# CITY OF ALBUQUERQUE

**Re: Arroyo Vista Apartments, Phase 6. (Final)**  
**4201 Bryn Mawr 87107**  
**Request for Certificate of Occupancy**  
**Transportation Development Final Inspection**  
Engineer's/Architect's Stamp dated 11-4-16 (G16D153)  
Certification dated 10-26-18

## TRAFFIC CIRCULATION LAYOUT APPROVED

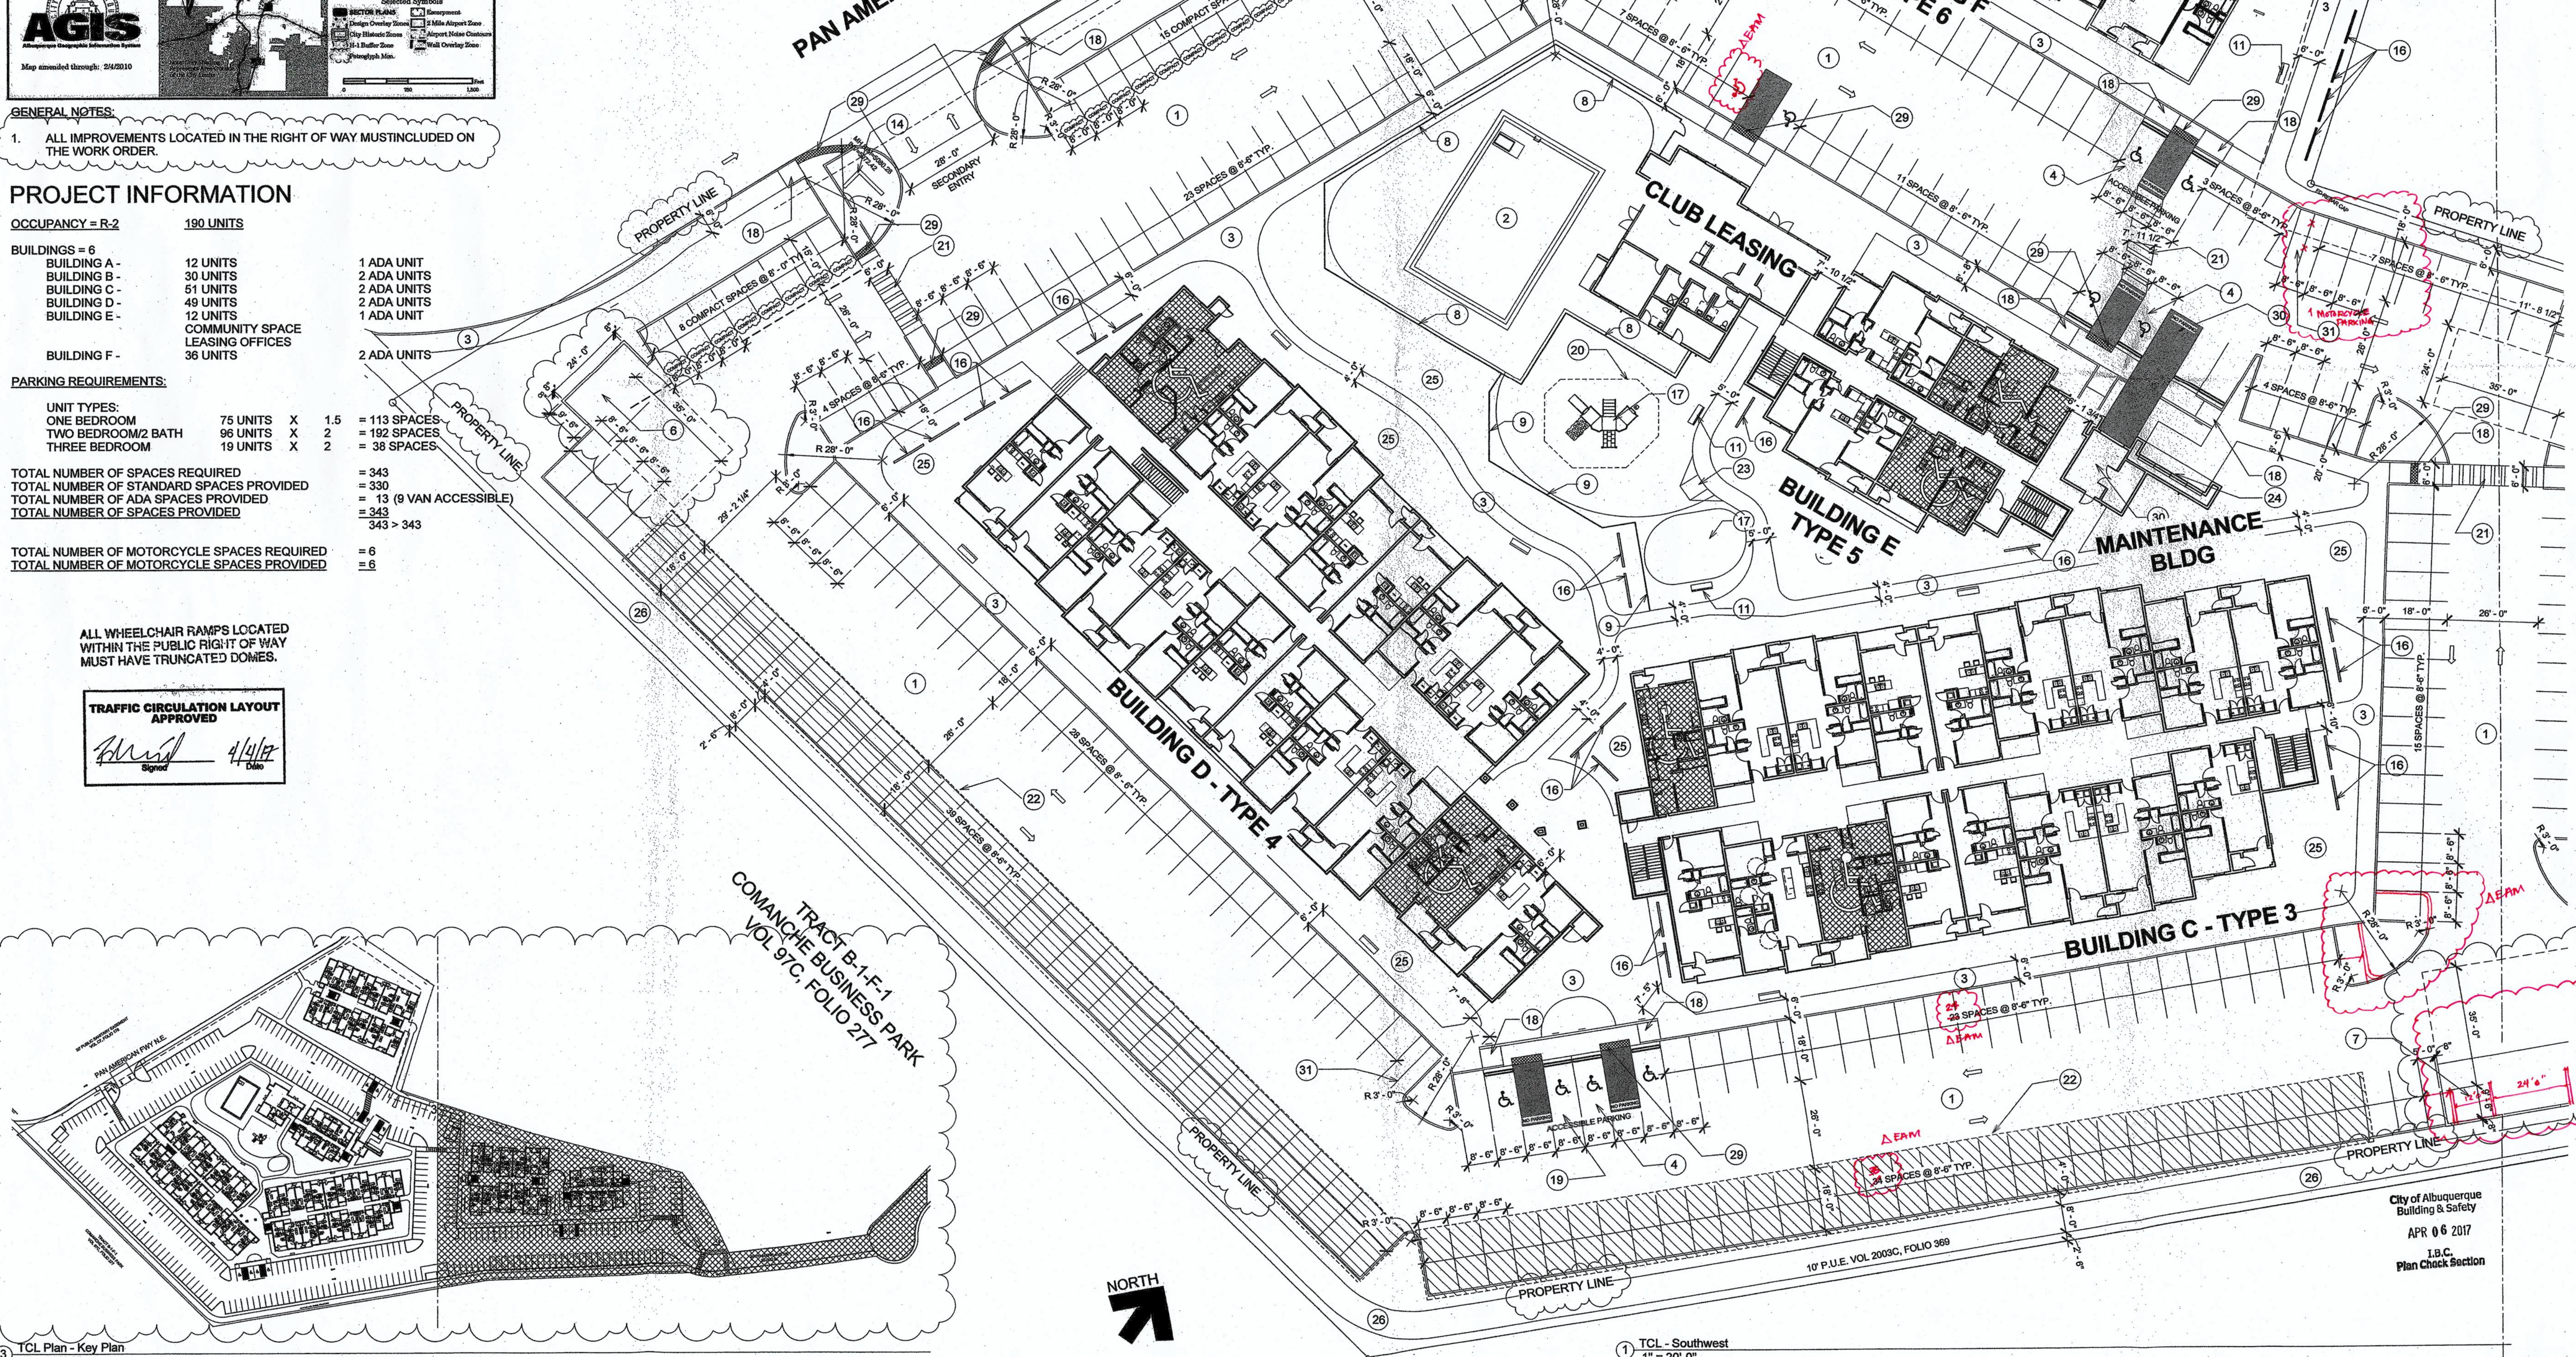
1. Please add missing truncated domes per approved TCL plan.
2. Please complete curb where canopy is being constructed over parking stalls. (Entrance of complex off Bryn Mawr).
3. The Work Order Infrastructure Must be closed out and accepted by the City of Albuquerque.
